PCN-20231004 TE0711-01 to TE0711-02 Hardware Revision Change

Company	Trenz Electronic GmbH
PCN Number	PCN-20231004
Title	TE0711-01 to TE0711-02 Hardware Revision Change
Subject	Hardware Revision Change
Issue Date	2023-10-23

This change affects all Trenz Electronic TE0711 SoMs: TE0711-01*.

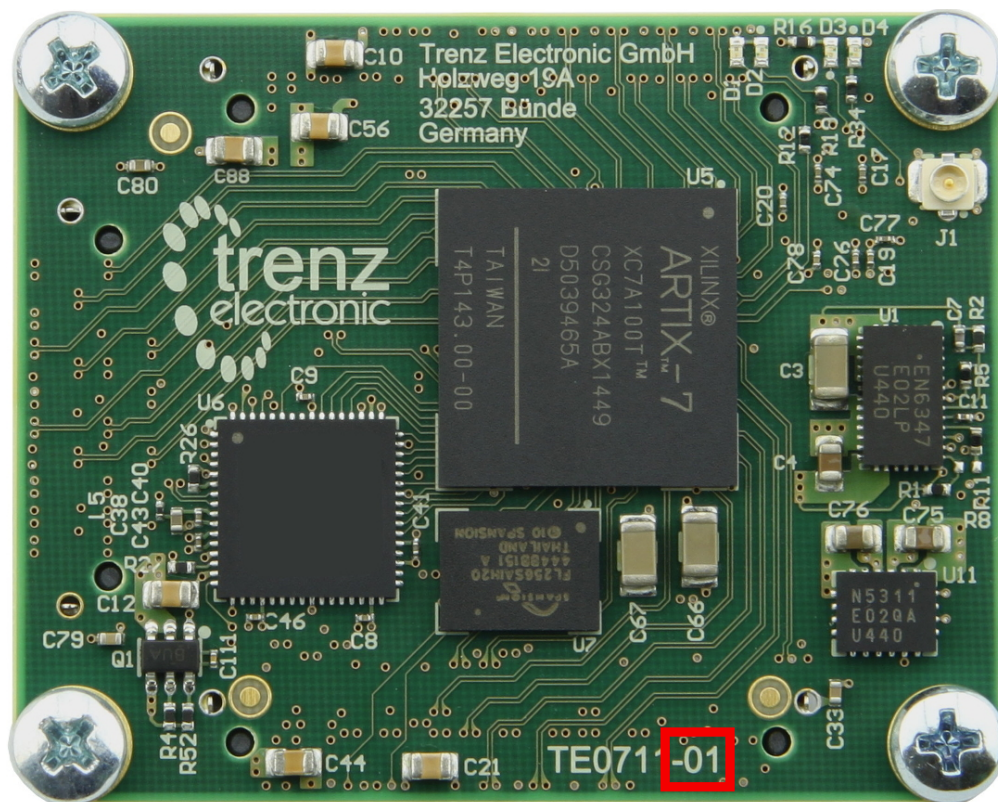
#19 Updated legal notices, revision history, block and power diagram. Updated page count and order.
